**City of Oakland
Objective Design Standards and
Project Streamlining**

**Focus Group Meeting #1
August 24, 2023**

City of Oakland Objective Design Standards & Project Streamlining Focus Group Meeting #1

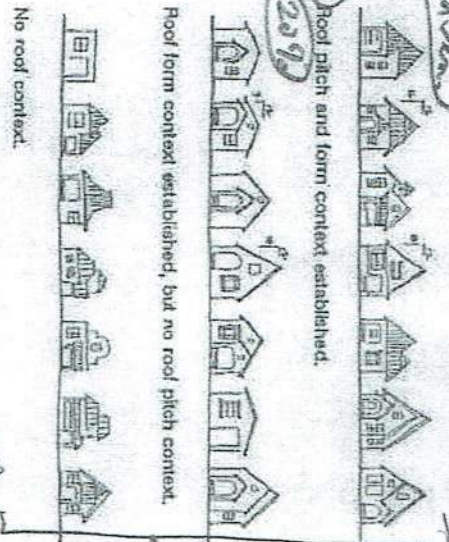
To determine if there is a ~~strong~~ roof pitch and form context, at least 80% of the buildings must have similar shapes (gable, hip, gambrel, mansard, etc.), and similar slopes as defined by four categories:

If there is a roof shape and/or a roof slope context, the proposal ~~should~~ conform to all established contexts, including overhangs if established in the context. In order to be considered as a successful response to this context, the roof form and shape context must apply to at least 75% of the project's roof area. See Fig. 8-3 & Fig. 8-4.

"CHANGE ALL SHAPES TO 'SHALL'"

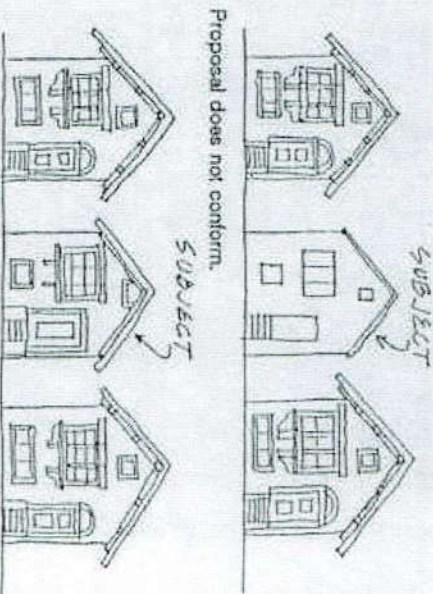
If there is an architectural detail context, the proposal ~~should respond to or approximate~~ the prevailing characteristics identified in the context. See Fig. 8-12x and Section 8.8 (Architectural Style Context).

Should incorporate

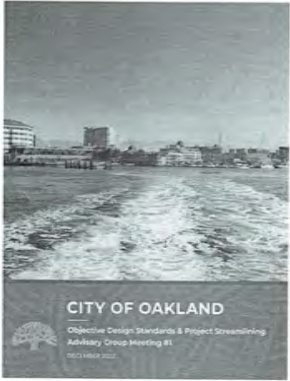
Page 1 of 14: Unfortunately, objective design standards must be prescriptive in order to be "objective." discretionary design review is still an option for projects that don't meet the objective standards.

UNFORTUNATELY, OBJECTIVE DESIGN STANDARDS MUST BE PRESCRIPTIVE IN ORDER TO BE "OBJECTIVE". DISCRETIONARY DESIGN REVIEW IS STILL AN OPTION FOR PROJECTS THAT DON'T MEET THE OBJECTIVE STANDARDS.

BE CAREFUL WITH THIS. BEING OVERLY CREATIVE COULD RESULT IN INTRUSIVE WITHIN ARCHITECTURALLY COHERENT NEIGHBORHOODS

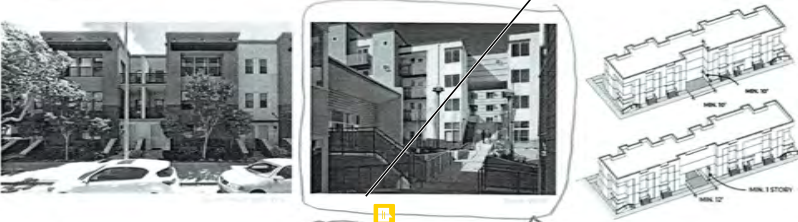
Page 4 of 14: DELETE "Massing Breaks" passage. Again, these techniques can intensify perceived bulk by making the building look too busy. Totally flat façades are acceptable if using coherent, regular façade rhythm, established by regularly spaced window columns and using horizontal divisions to separate the bottom and top floors from the overall building mass. Cornices and other detailing can help, along with patterned surfaces such as brick, stone, and wood siding. See the 300-foot long ca 8-story Hotel Oakland, 14th St. side, for a good example. See also OHA 4/30/21 comments.

Second photo on page 4 of 14: too many articulations, design is too cluttered and visually disruptive. Use discretionary design review.

DELETE AGAIN, THESE TECHNIQUES CAN INTENSIFY PERCEIVED BULK PAGE 4 OF 14
BY MAKING THE BLDG. LOOK TOO BUSY. TOTALLY FLAT FACADES ARE ACCEPTABLE IF USING COHERENT REGULAR FACADE RHYTHM ESTABLISHED BY REGULARLY SPACED WINDOW COLUMNS + USING HORIZONTAL DIVISIONS TO SEPARATE THE BOTTOM FIVE FLOORS FROM THE OVERALL BUILDING MASS. CORNICES AND OTHER DETAILING CAN HELP ALONG WITH PATTERNED SURFACES SUCH AS BRICK, STONE AND WOOD SIDING. SEE 300' LONG CA. 8 STORY HOTEL OAKLAND 14TH ST. SIDE FOR GOOD EXAMPLE. SEE ALSO 4/30/21 COMMENTS.

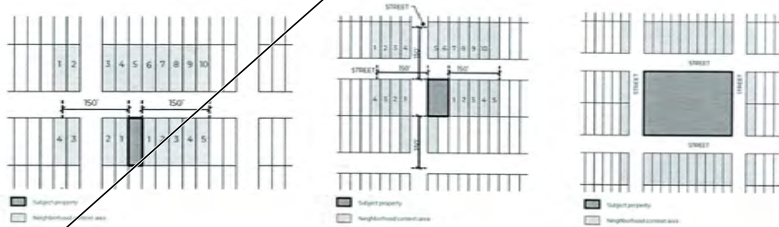
Page 7 of 14: Use Alameda text, which is clearer. Also, change 150 to 250 feet. Define context in terms of neighboring lots that are close enough to the project site to be viewable with the project.

Page 10 of 14

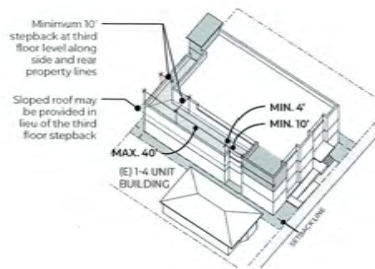
No, depends on prevailing façade width in context. No. of units is not relevant. See also Bulk comments.

PAGE 14 OF 14

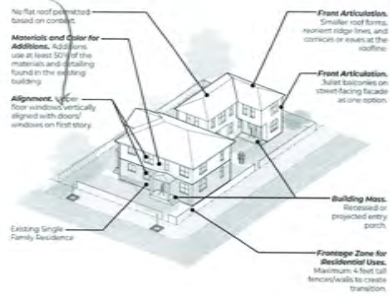
SEE ALAMEDA ADDITIONS/ALTERATIONS STANDARDS.
